From: Greib, Gary R
To: Brian Stouffer
CC: Greib, Gary R
BCC:
Sent Date: 2013-10-29 19:06:43:000
Received Date: 2013-10-29 19:07:37:348
Subject: FW: Request for Information Chevrolet Cobalt Ignition Switch P/N 10392423
Attachments: [57128dat.doc](#) , [741-75259_Detent spring & plunger.pdf](#) , [NME74179378_A\[1\]_Detent spring & plunger.pdf](#) , [NME74176307S_D.pdf](#)

Engineering Change Support Information Cover Page

This information support the implementation on New PCB 12861211 Rev 5 and the New Detent Plunger 741-79378.

Part Name* GMX 357 Delta Ignition Switch Part Number* 10392423 Release Level* 001
Shown on Drawing No.* 10392423 / 22673857 Engineering Design Record Change Level* N/A Dated* 27AP04
Procuring Division* NAO Application/Program* GMX 357 Purchase Order No.*
GM Lead Engineer* Ray DeGiorgio GM Validation Engineer*

741-75259

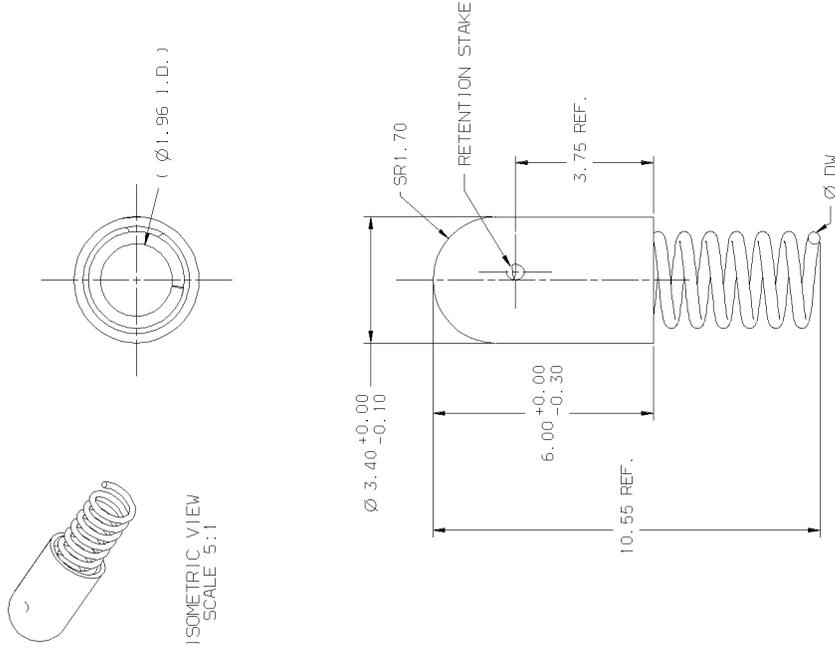
- Previous revision, rev D, of Delphi p/n NME74176307 (GM p/n 10392423) was also released under CA191471. In the revision block of this print, it is stated that detent spring & plunger assy p/n 74-179378 was previously p/n 74-175259 in revisions B and A, and it was changed on revision C. The date of this change is 04/21/06 and it was authorized by Engineering Change 57128 (attached for your reference). Print of p/n 74-175259 was never released on GES but it was found in an old database from Condura/Eaton (attached are both prints for the also for the detent spring & plunger assy your reference as well as the print of rev D of Delphi p/n NME74176307/GM p/n 10392423). When comparing them you can see that they are different.

In summary, Engineering Change 57128 authorized, among other things, to change detent spring & plunger assy from p/n 74-175259 to p/n 74-179378 (NME74179378 when released on GES). Looking at the prints of both part numbers they are different and match with the differences described below.

Note that the during cycling, 1 amp was applied on the Delta Ignition Sw. This validation was submitted with New PCB correct timings adjusts as Customer required, also New detent plunger (Catera spring/Plunger) was implemented to increase torque force in the switch.

Ray DeGiorgio (GM RDE) agree to implement change without changing GM p/n. He provides his approval with GM3660 to implement both changes.
